# Technical Document LA24002

## Part 2 – Technical Requirements

Application under the Agricultural Operation Practices Act for a confined feeding operation, manure collection area, and/or manure storage facility(ies)

<b>NRCB USE ONLY</b>	Application number	Legal land description
	<input checked="" type="checkbox"/> Approval <input type="checkbox"/> Registration <input type="checkbox"/> Authorization <input type="checkbox"/> Amendment	<u>LA24002</u>

Figure 1 – Van Huigenbos Farms – Proposed Feedlot Expansion Map

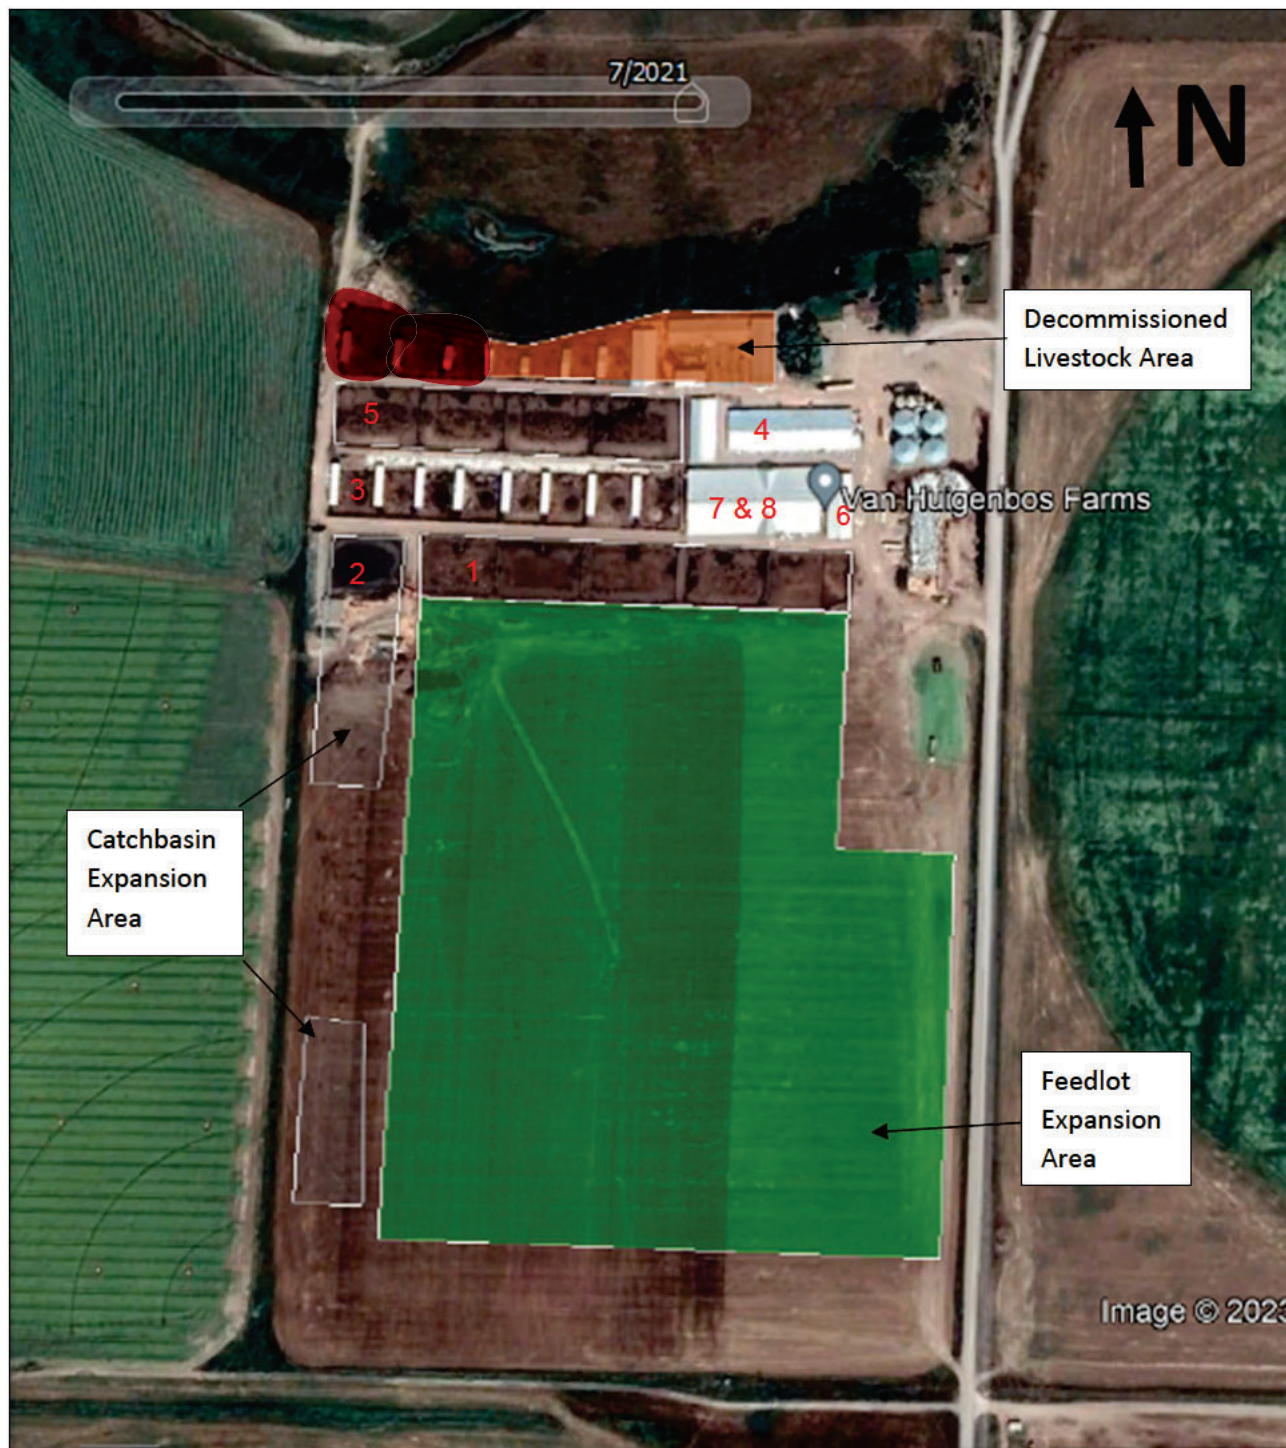
AO Comment: Condition in Approval LA24002 requiring the decommissioning of the entire north row of pens (highlighted in red and orange).

AO Comment: Numbers in Figure 1 correspond with list of existing facilities on page 2 of this document.

**A** PLAN  
 FEED LOT AREAS  
 SCALE: 1:1800

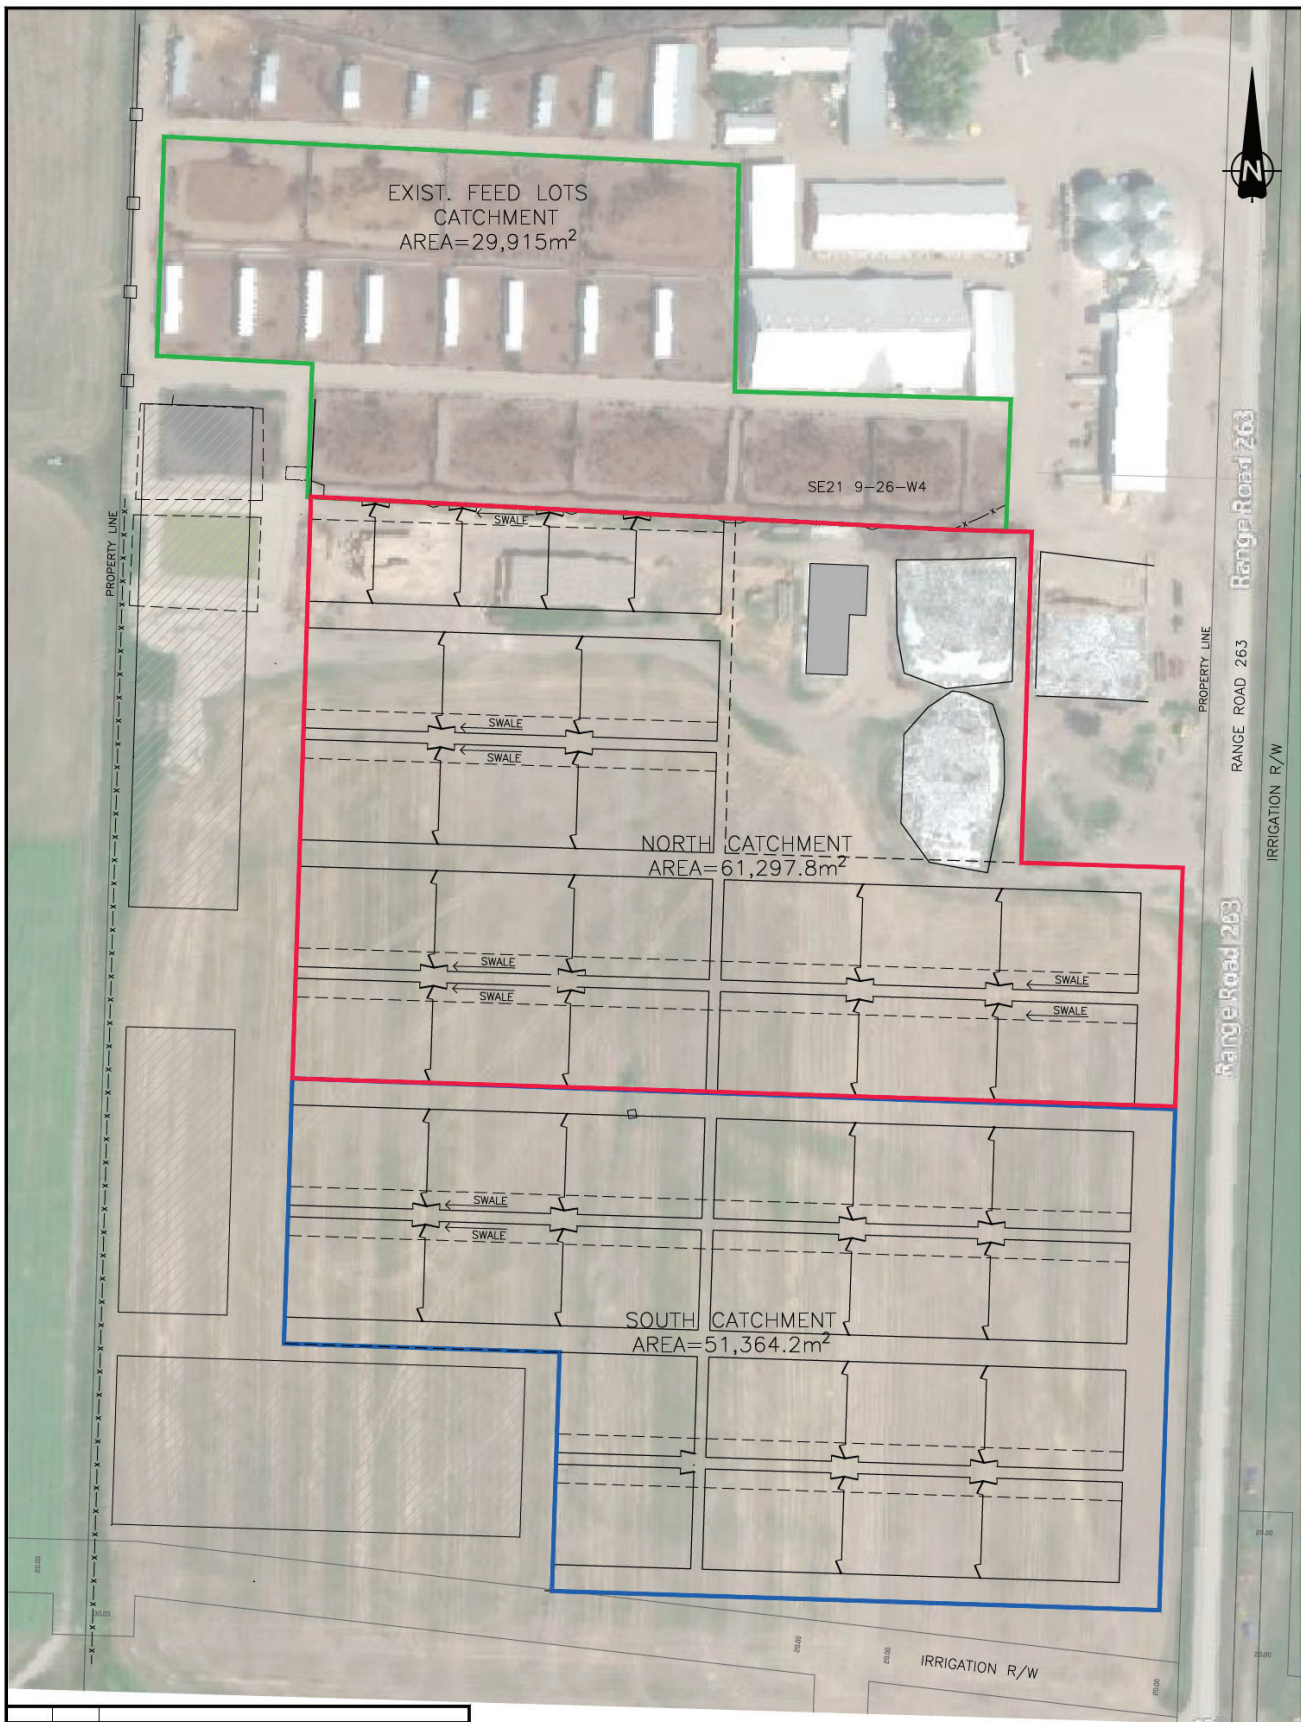
AO Comment: All run-off is directed to catch basins.
